PETITION NO: Z-18

PROPOSED ZONING: RRC

PROPOSED USE: Mixed-Use
Development

ZONING COMMENTS:

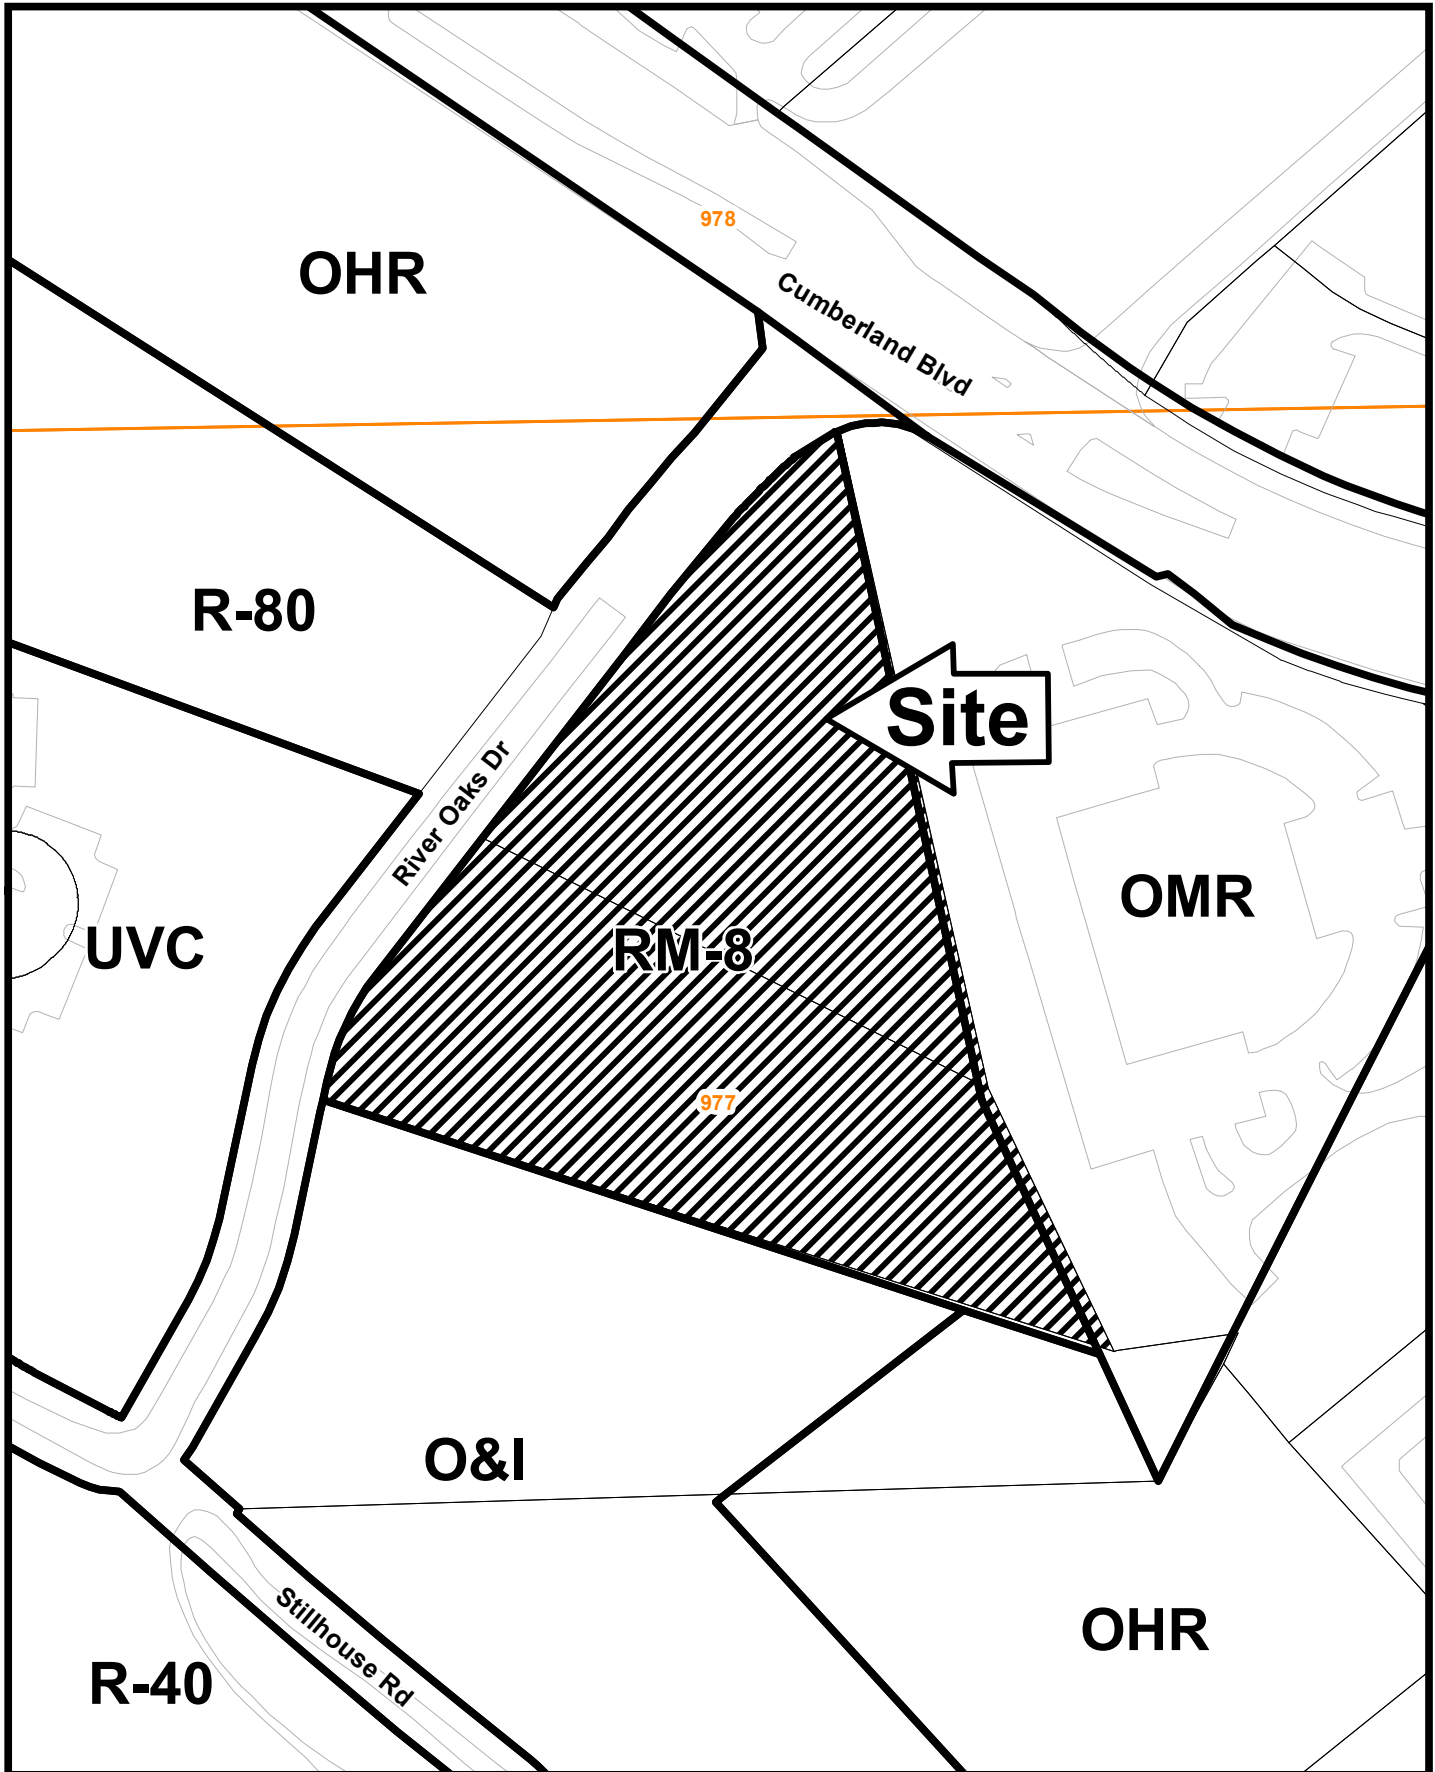
- No Stormwater controls shown _____
- Copy of survey is not current – Additional comments may be forthcoming when current site conditions are exposed.
- No site improvements showing on exhibit.

The site roadway configuration and retaining wall located in the right-of-way do not meet Cobb DOT standards.

The site roadway configuration and retaining wall do not meet Cobb County DOT standards. Recommend roadway design and retaining wall details to be determined during plan review, subject to Cobb County DOT approval.
